Access Compliance Report

Public Rights-of-Way

Intersection ID: 27624	Main Street: BALLANTYNE_MEADOWS_DR	Cross Street: JAMES JACK_LN	Location: NW
ADA ID: 5F724441FEA0	Ramp Type: Perp	Initial Pass/Fail: Fail	Overall Compliance: No
		Severity Score: 12.5	
Codes/Mitigation Info/Possible Solution		Field Measurements/Component Compliance

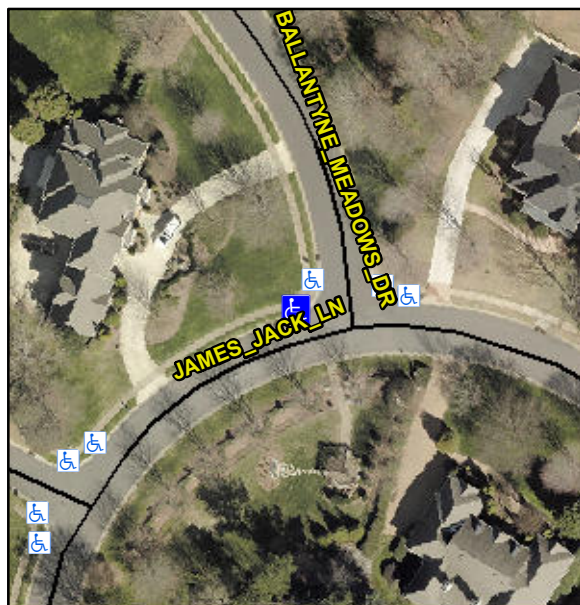
Not Found, R304.5.3

Compliance	Description	Data	Compliance	Description	Data
N/A	Ramp Length (in)	46.0	Yes	Ramp Slope (%)	5.3
Yes	Ramp Width (in)	48.0	No	Ramp XSlope (%)	6.8
N/A	Flare Type LT	N/A	N/A	Flare Type RT	N/A
N/A	Flare Slope LT (%)	N/A	N/A	Flare Slope RT (%)	N/A
N/A	Flare Traversable LT?	N/A	N/A	Flare Traversable RT?	N/A
N/A	Landing Length (in)	N/A	N/A	DWS Provided?	N/A
N/A	Landing Width (in)	N/A	N/A	DWS Contrast?	N/A
N/A	Landing Slope (%)	N/A	N/A	DWS Length (in)	N/A
N/A	Landing X Slope (%)	N/A	N/A	DWS Full Width?	N/A
N/A	Landing Curb? (Y/N)	N/A	N/A	DWS Offset (in)	N/A
N/A	Shared Landing?	N/A			
N/A	Gutter Ponding?	N/A	N/A	Gutter Slope (%)	N/A
N/A	Gutter Lip Ht (in)	N/A	N/A	Gutter X Slope (%)	N/A
N/A	Painted X Walk1?	No	N/A	Painted X Walk2?	N/A
	X Walk 1 Direction	To S		X Walk 2 Direction	N/A
N/A	X Walk 1 Width (in)	N/A	N/A	X Walk 2 Width (in)	N/A
	X Walk 1 Slope (%)	4.9		X Walk 2 Slope (%)	N/A
	X Walk 1 X Slope (%)	4.7		X Walk 2 X Slope (%)	N/A

Remove & Replace Entire Ramp.
